NOTIFICATION

#0013

SUBJECT: Approval of use of Rotax cover plate to seal hydraulic constant speed governor drive attachment face on Rotax 915 iS-3-A engines.

MODELS AFFECTED: All Sling aircraft fitted or to be fitted with the Rotax 915 iS-3-A engine, and in which no hydraulic governor is used / to be used.

FIG A

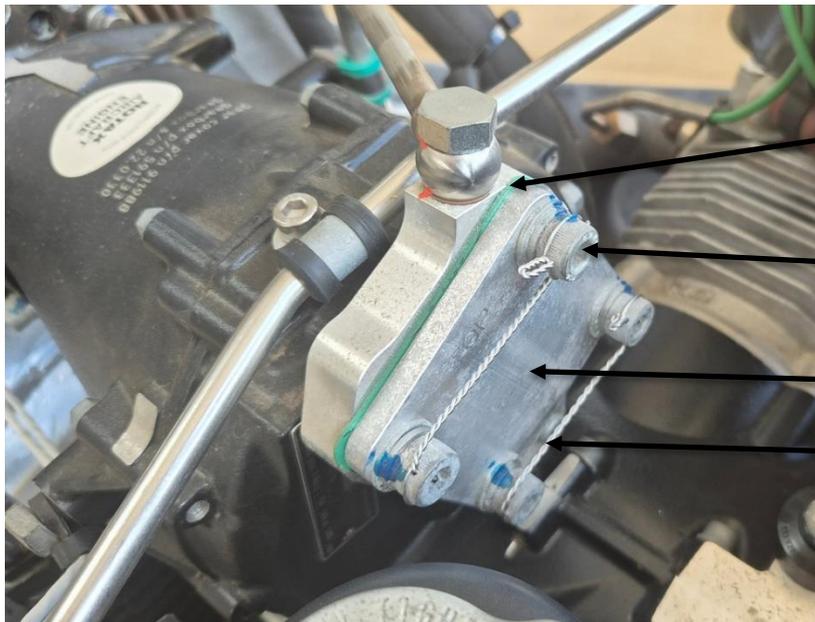
The ROTAX 915iS-3-A engine is supplied with an hydraulic constant speed governor drive designed for controlling hydraulically adjustable propellers. Such engines are supplied by the manufacturer with a “cover plate” for factory test running, transport, handling and protection of the drive (see Fig A).

Sling Aircraft (“Sling”) has performed comprehensive testing and has determined that, where an hydraulic governor is not used (eg – where an electrically controlled propeller is used), operating the ROTAX 915iS-3-A engine with the cover plate installed is safe, subject to proper installation.

This notification accordingly serves to confirm that Sling Aircraft approves the use, in Sling aircraft models, of the ROTAX 915iS-3-A engine with the cover plate fitted in place of an hydraulic governor system.

- If the cover plate is fitted with bolts which are drilled for wire-locking and lock wire has been fitted (as in Fig 1), the installation can be considered satisfactory;

- If the cover plate has been fitted with a flat AND a split washer, the bolts should be checked for the correct torque, namely 24Nm (18 ft.lb) and torque seal applied. When correctly torqued the installation can be considered satisfactory;

- If the cover plate has been fitted with only flat washers (unlikely), then the bolts should be removed, cleaned, reinstalled using Loctite 243 to ensure that they do not vibrate loose, torqued to 24Nm (18 ft.lb) and torque seal applied. Once correctly torqued the installation can be considered satisfactory;

- If there is any leakage of oil from around the cover plate the cover plate should be removed, cleaned, fitted with a new gasket if the existing gasket is damaged, and reinstalled with wire-locking, split washers or Loctite 243 to prevent loosening, as the case may be. Once re-installed in accordance with these instructions the installation can be considered satisfactory.
